Applicant : Cemal Shener et al.  
Serial No. : 10/685,590  
Filed : October 16, 2003  
Page : 11 of 16

Attorney's Docket No.: 00167-460001 / 02-31-0389

Amendments to the Drawings:

FIG. 1F

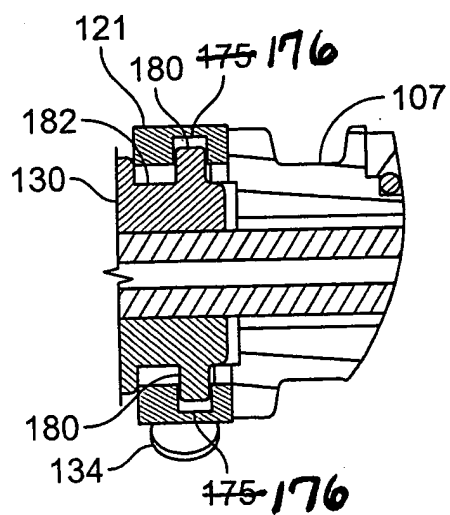
In Figure 1F, reference numeral "175" has been changed to reference numeral "176."

The drawings and the specification have been objected to as using the same reference character "175" to designate both an inflow port and L-shaped channels. Applicants have amended the drawings and the specification to use the reference character "176" to designate the L-shaped channels. Accordingly, applicants request reconsideration and withdrawal of this objection.
